Project: River Road Elementary School – Building and Site Construction
Title: Addendum No. 1
Contract No: CIP 410 307 001
Date: March 1, 2016
From: John Stapleton, PIVOT Architecture
To: Interested Bidders

This Addendum is available at <http://www.4j.lane.edu/bids/> and modifies the Project Manual, Specifications, and Drawings in accordance with the Invitation to Bid and the Instructions to Bidders as follows:

7 SECTION 01
1/4" = 1'-0"

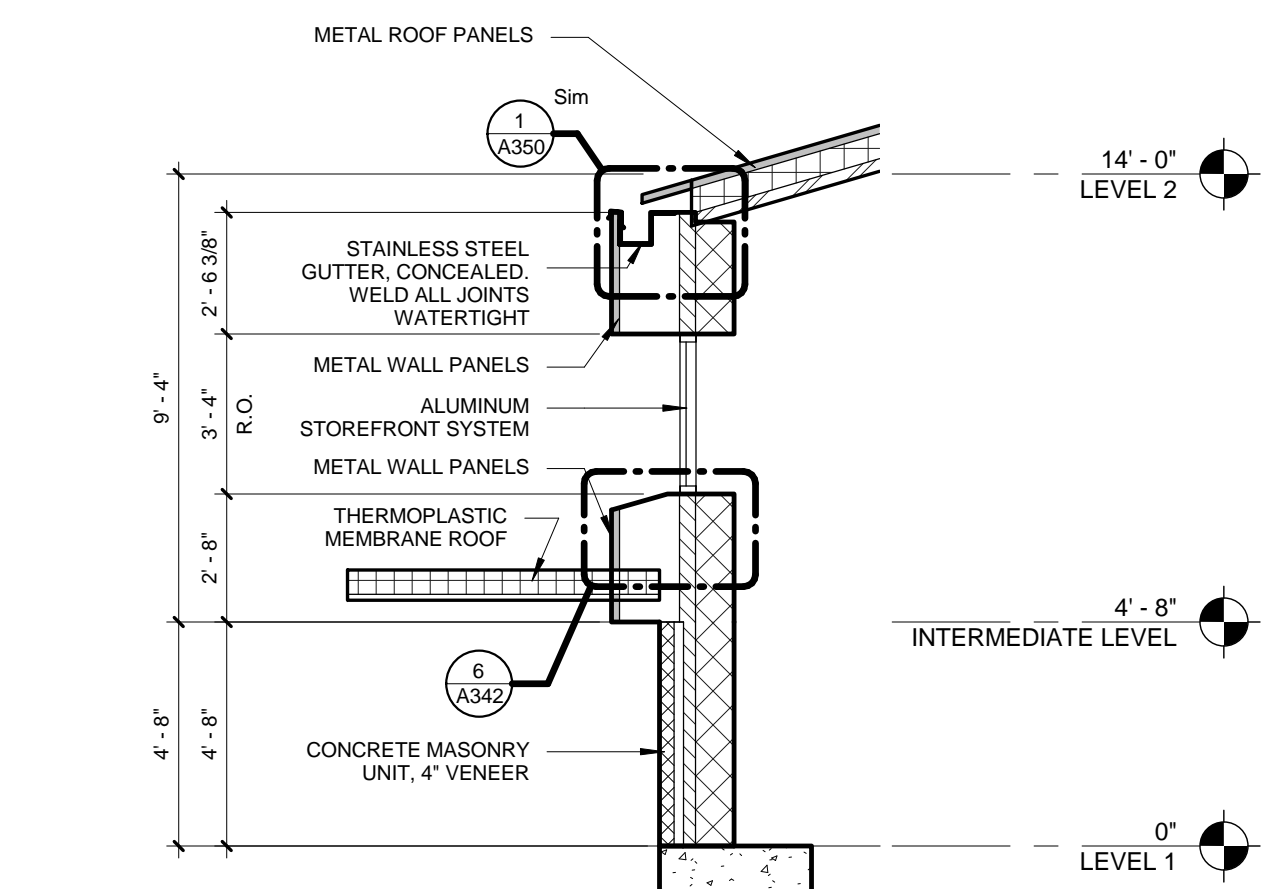
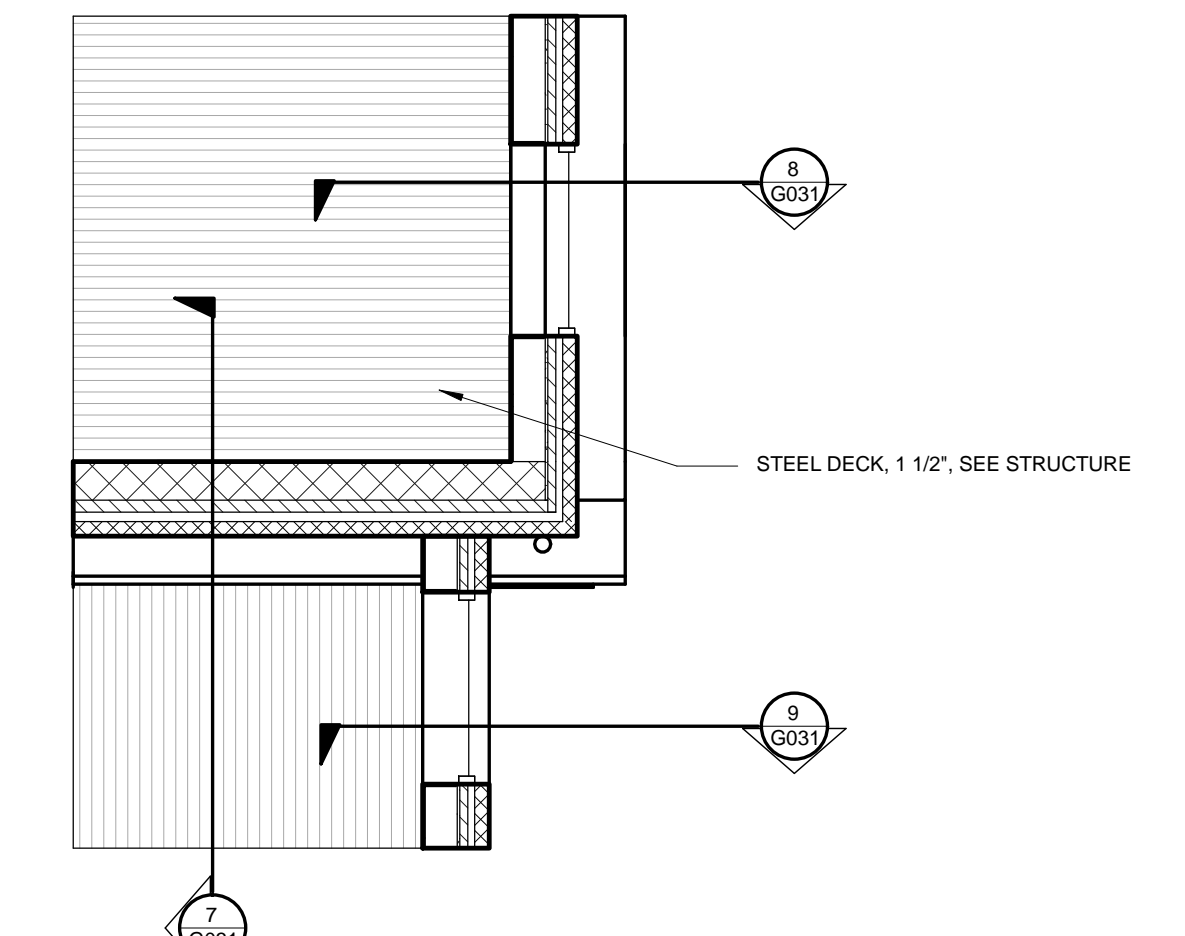
- 1-3-1 Sheet G011. Revised deferred submittal list.
- 1-3-2 Sheet G031. ADD Mockup detail sheet.
- 1-3-3 Sheet A112. Revised plan at elevator, revised keynote.

1 ELEVATOR SHAFT SECTION B127
1/2" = 1'-0"

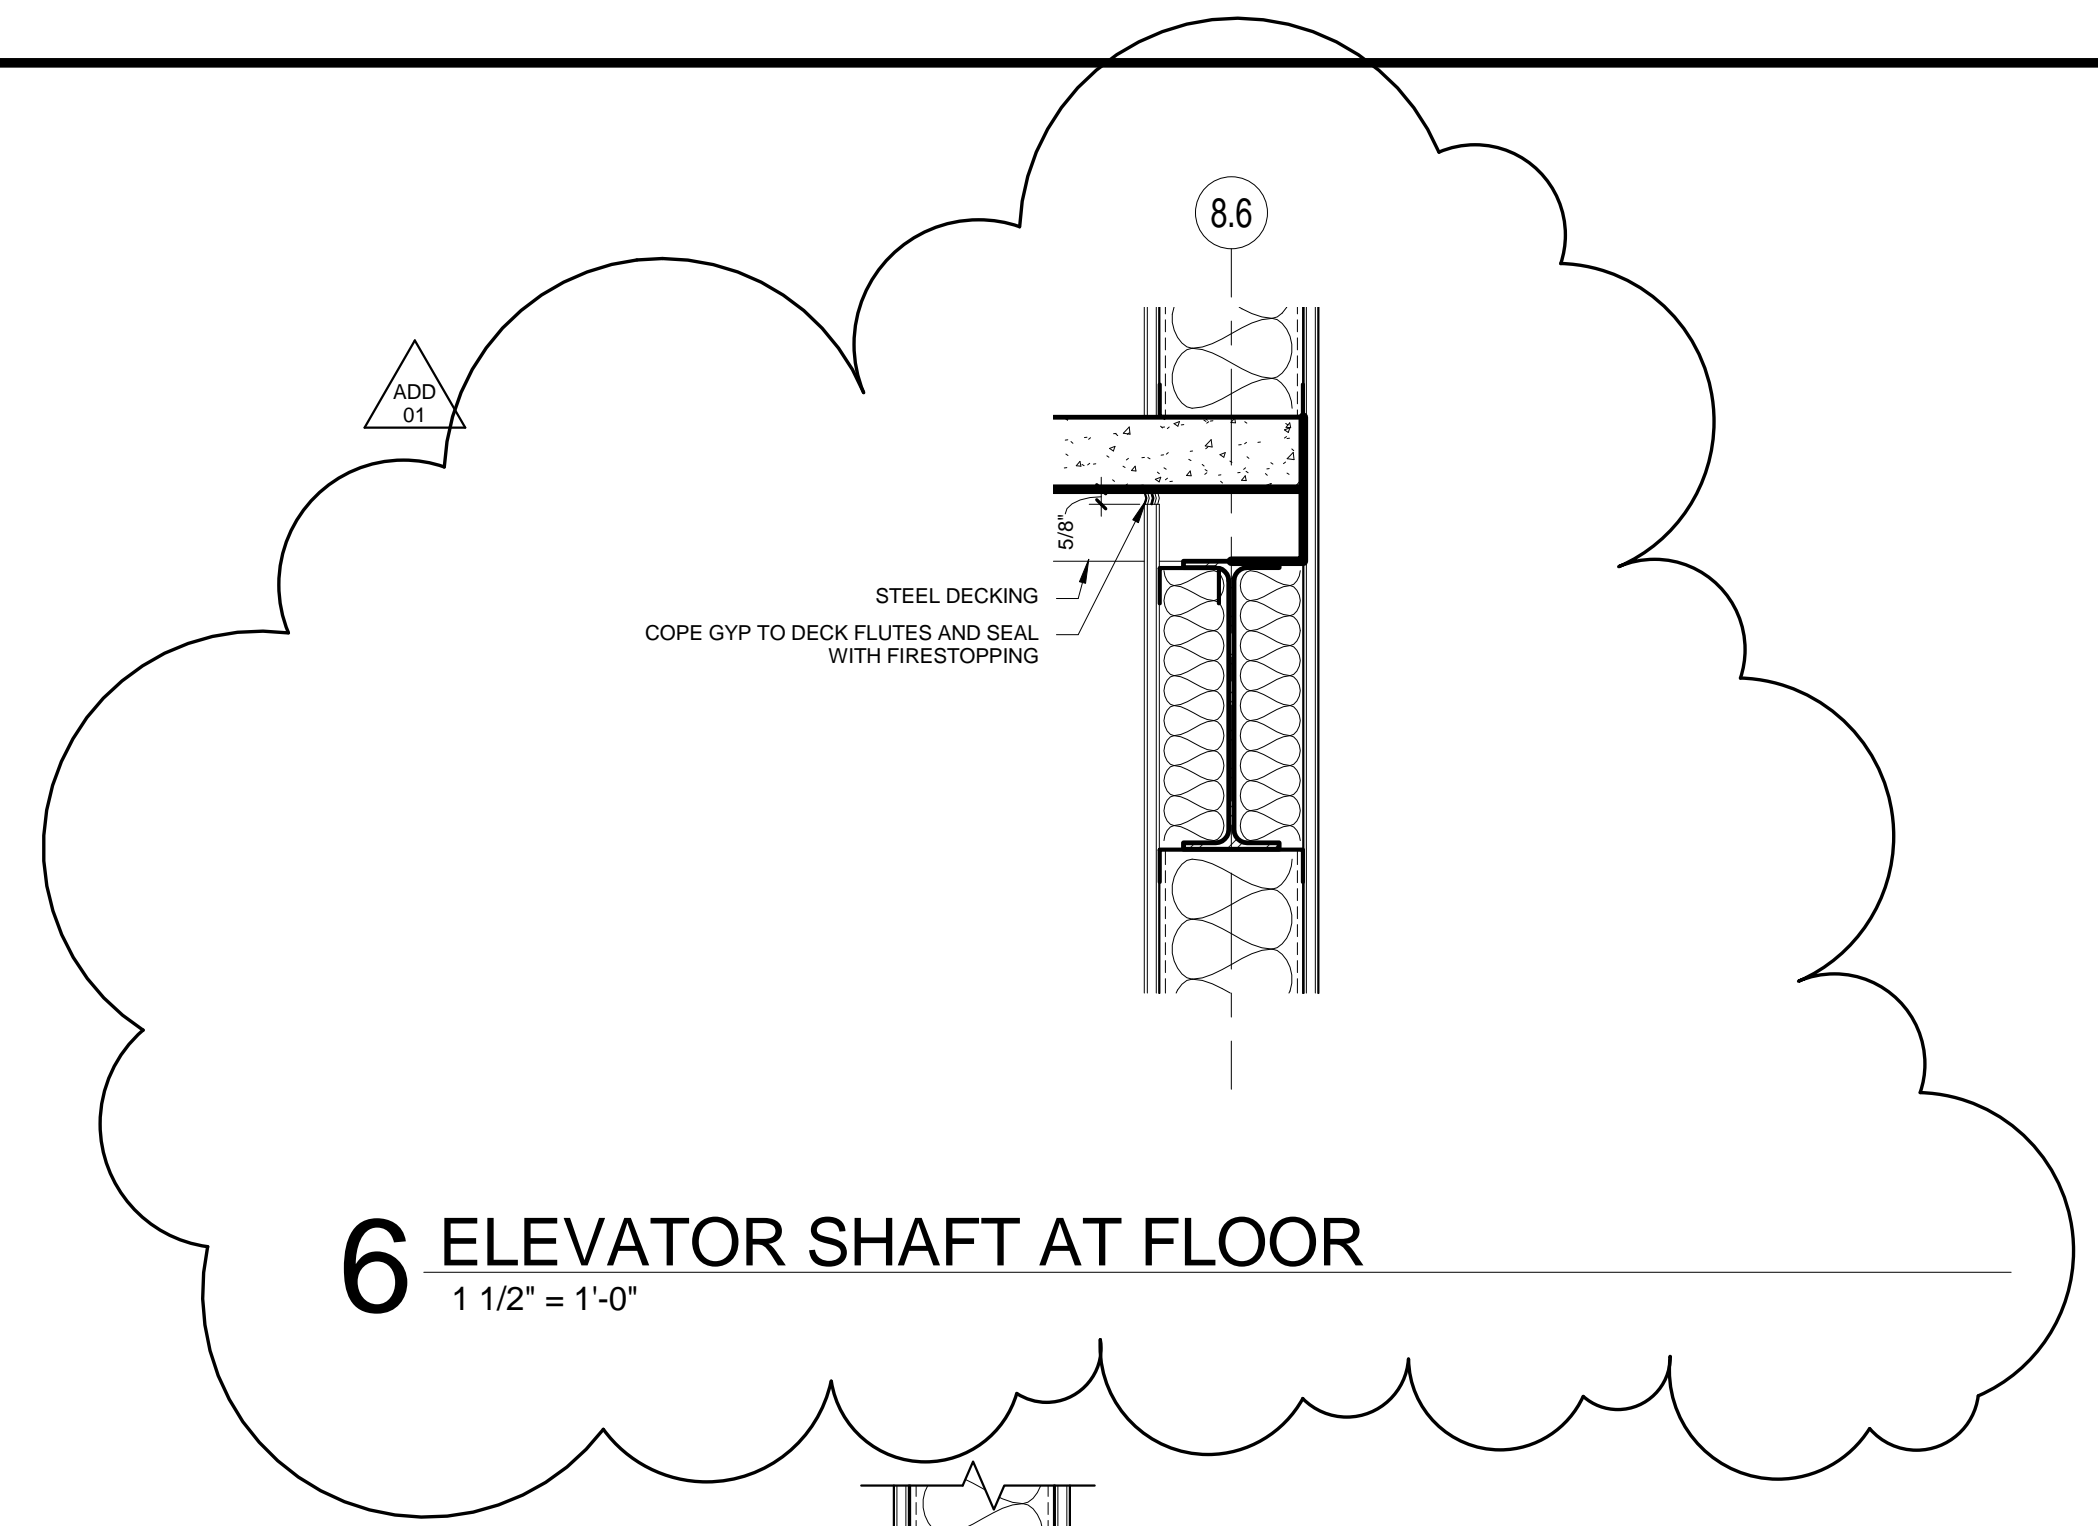
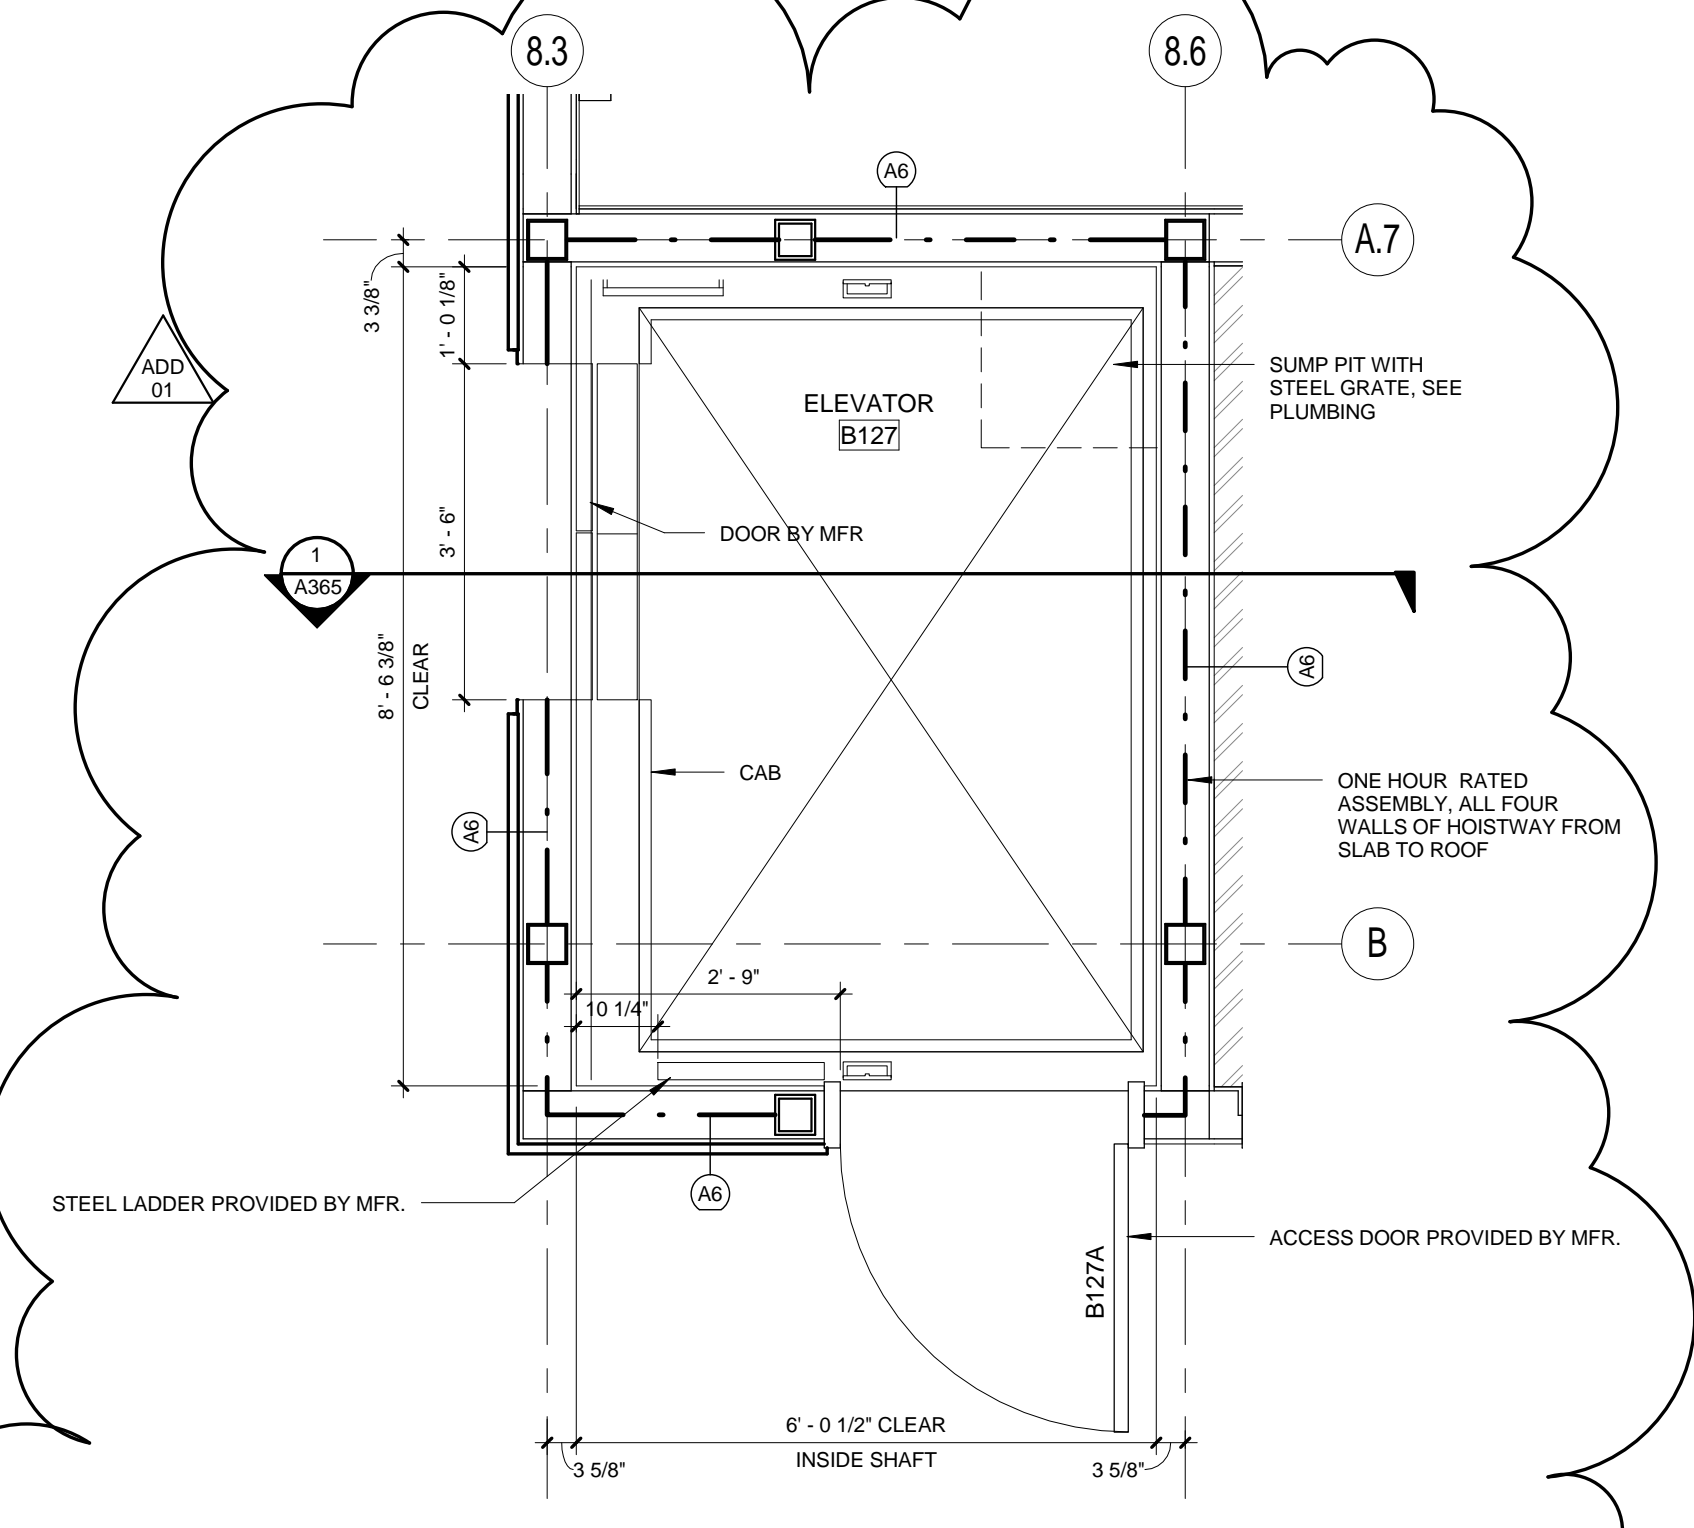
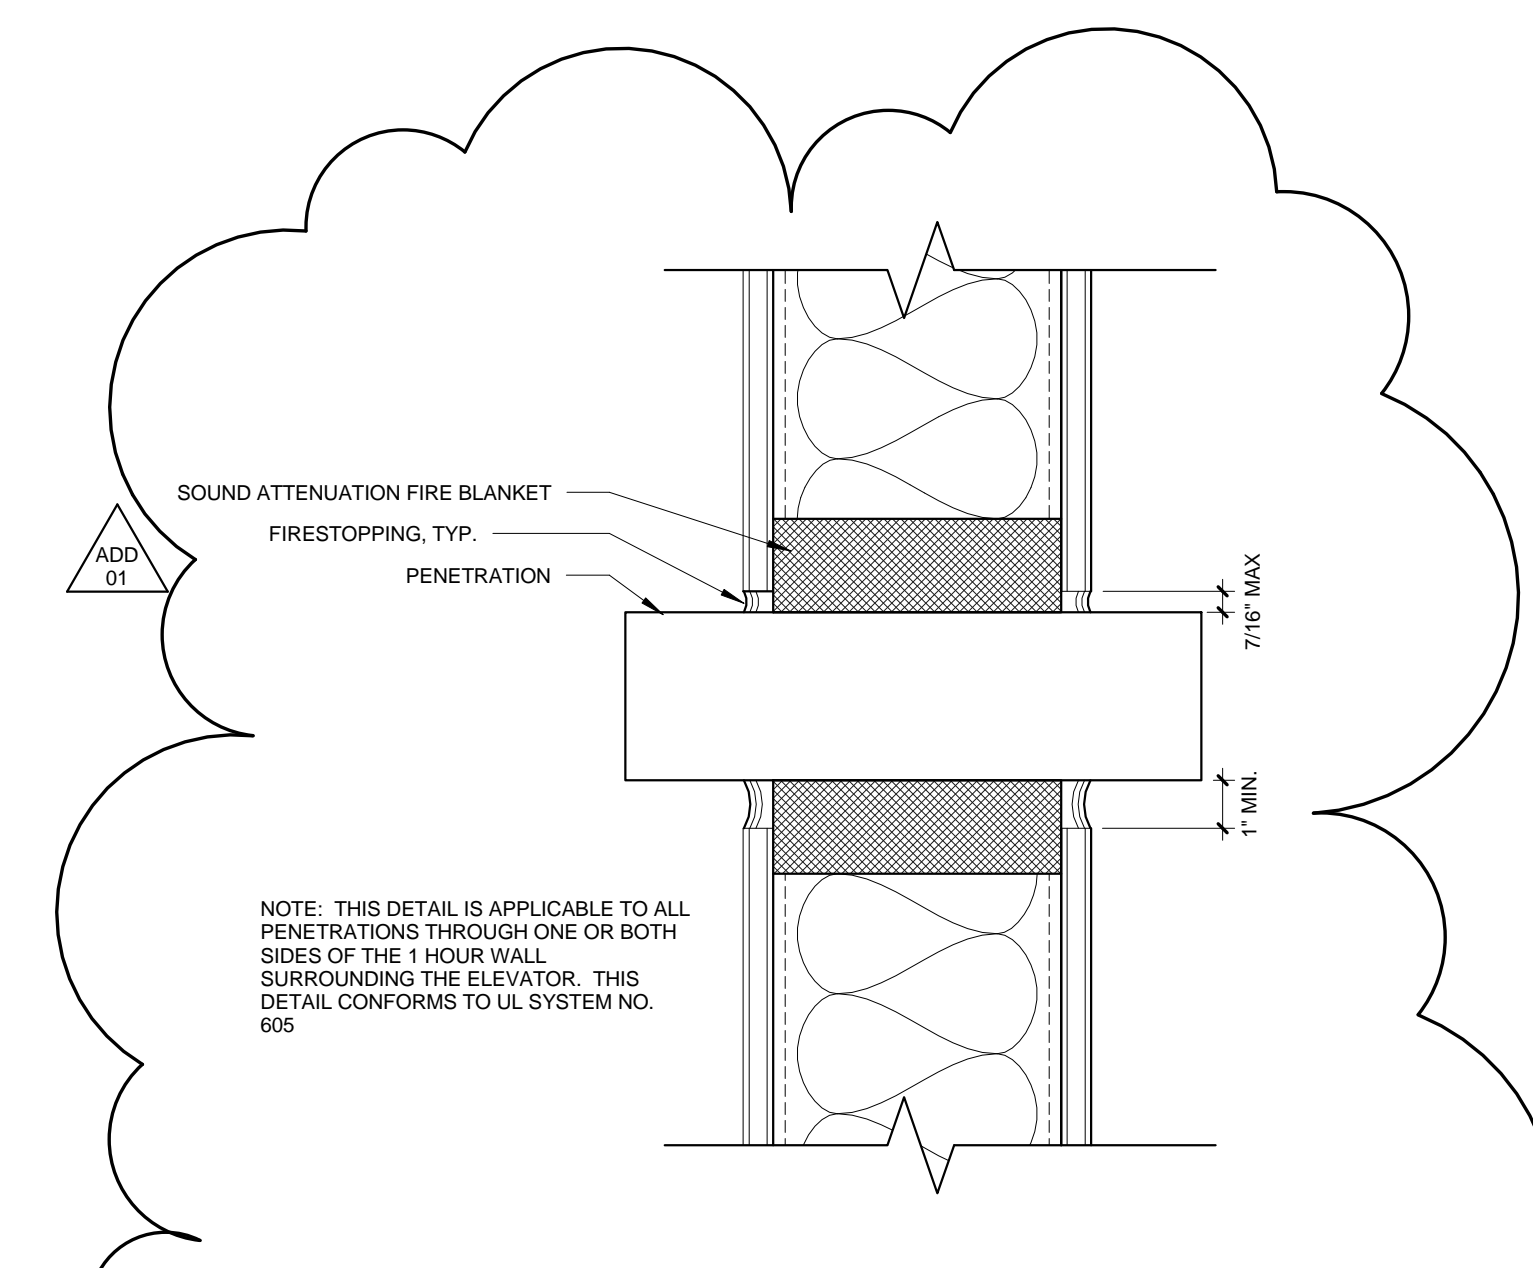
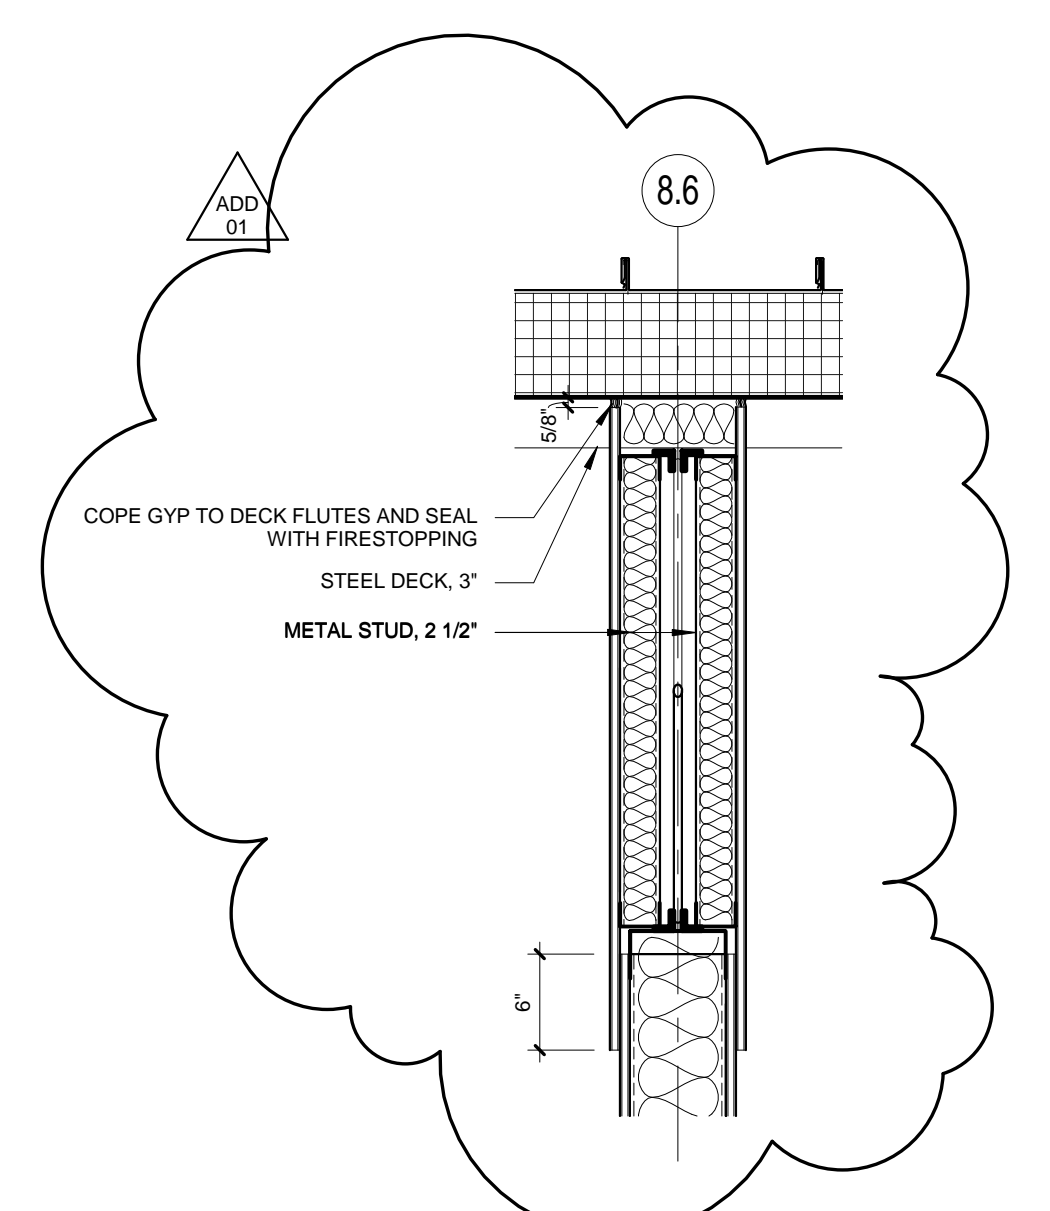
- 1-3-8 Sheet A215. This sheet was omitted from the initial ORPIN web posting. Add to Construction Documents.
- 1-3-9 Sheet A365. Revised elevator sections and details.
